Subject: Docket Nos. 50-361 and 50-362
San Onofre Nuclear Generating Station, Units 2 and 3

ATTACHMENT I

Notice of Violation

POST-WELD HEAT TREATMENT PROCESSES

Figure D-6. VERTICAL PIPE ENDS NOT BLOCKED 30F/INCH

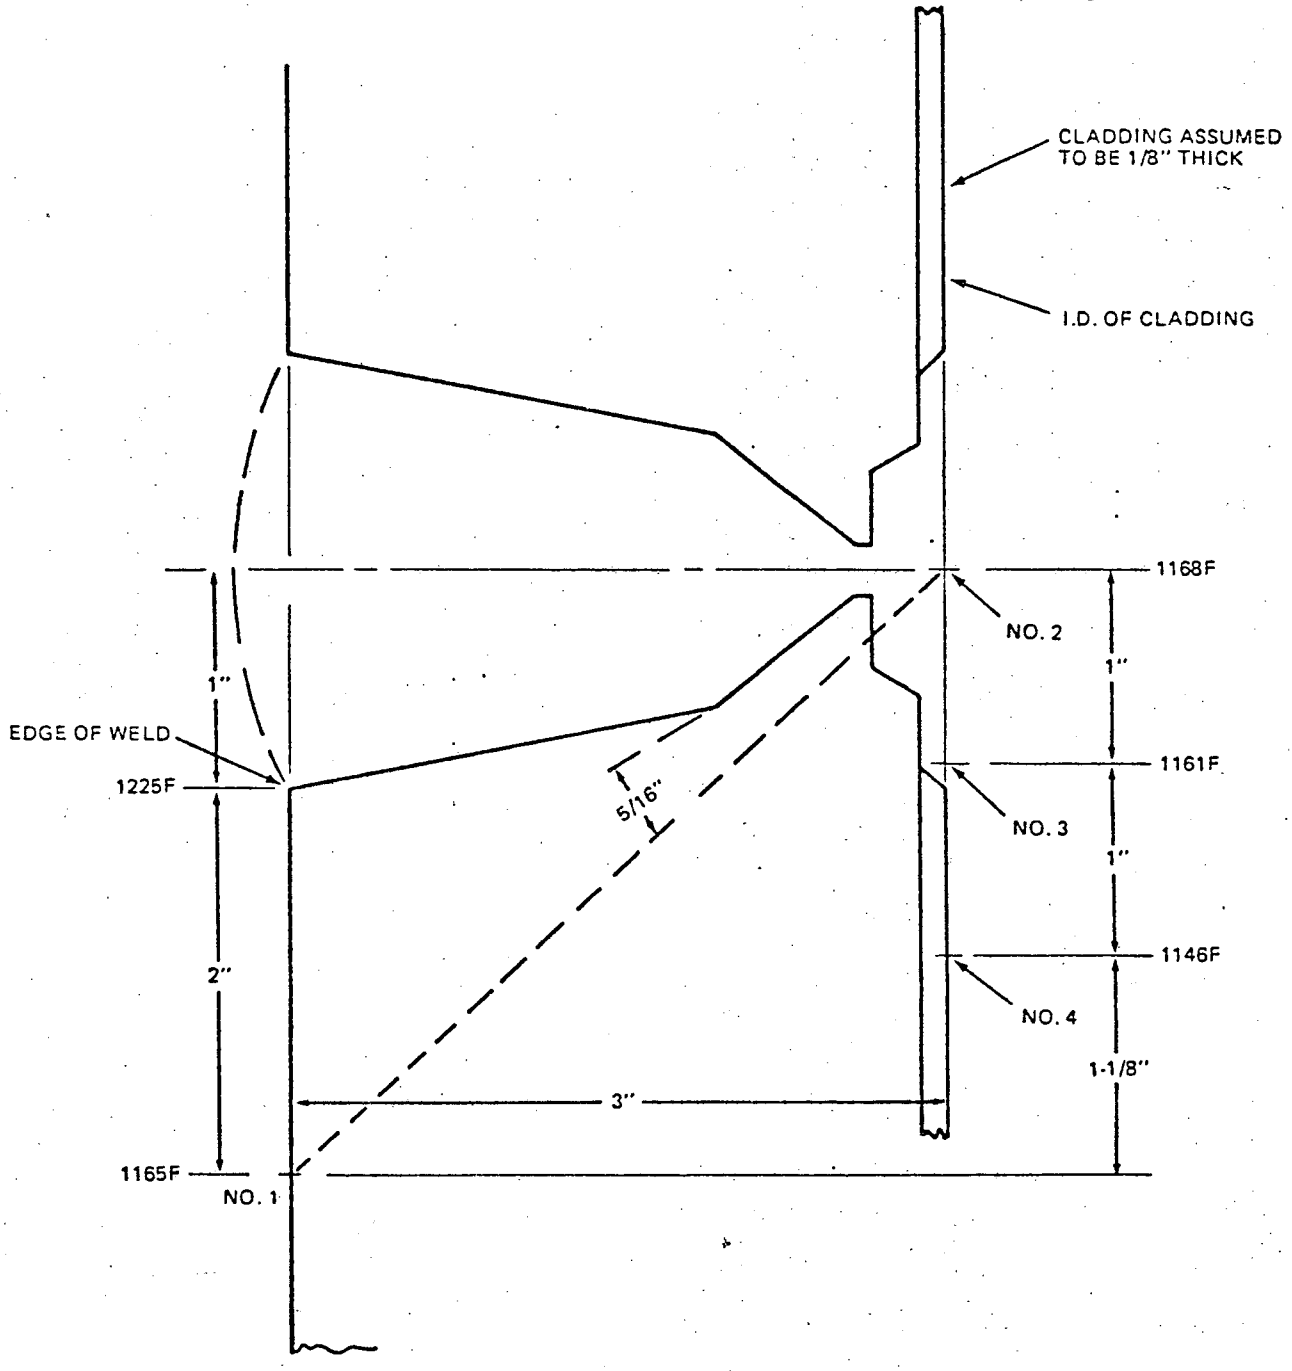
Contrary to the above, as of February 5, 1979, the post weld heat treating procedure using the quartz lamp technique had not been qualified before use to demonstrate that the minimum heat treating temperature of 1100°F, a design requirement, was met during the post weld heat treatment of main steam piping and reactor coolant piping welds. This procedure had been used since mid-1977 for heat treating the aforementioned welds at Units 2 and 3.

Figures D-1 through D-4 and D-5 through D-8 are in Appendix 4D and show the predicted inside pipe diameter temperatures for outside pipe diameter temperature gradients of 40, 30, 20 and 10F per inch. Outside pipe temperature gradients of 20 and 30F per inch are usually encountered in production welds. The 10 and 40F per inch gradients were modeled to bound the analysis. The pipe modeled had a 3-inch wall thickness, was in a vertical configuration, and had ends both blocked and unblocked. In all cases, a 10F/inch outside gradient yielded the lowest internal temperature. This configuration would yield the largest through-wall temperature gradients. With a reference temperature 2 inches from the weld edge of 1165F, the lowest internal temperature, 1 inch from the weld centerline (outside heat affected zone), calculated was 1138F with pipe ends unblocked. This is a maximum through-wall temperature gradient of 37F and confirms that the 3-inch and smaller wall thickness pipes are acceptable since these pipes were all heat treated at reference temperatures at least 40F above the required temperature. The effect of not blocking the ends of the pipe is an increase in the through-wall temperature gradient of 6F for the 3-inch wall thickness vertical piping.

The computer model predicted a temperature difference of minus 27F between the control thermocouple on a 3-inch thick vertical axis pipe and the internal weld centerline. The installation test data from Appendix C showed this temperature difference on a 3-3/8 inch thick (compared to 3-inch thick) vertical axis pipe to be 35F. This shows good correlation considering the thicker wall pipe, the difference in thermocouple placement, and the accuracy of the recorders. The good correlation justifies use of the program to predict the internal temperatures on thicker pipe.
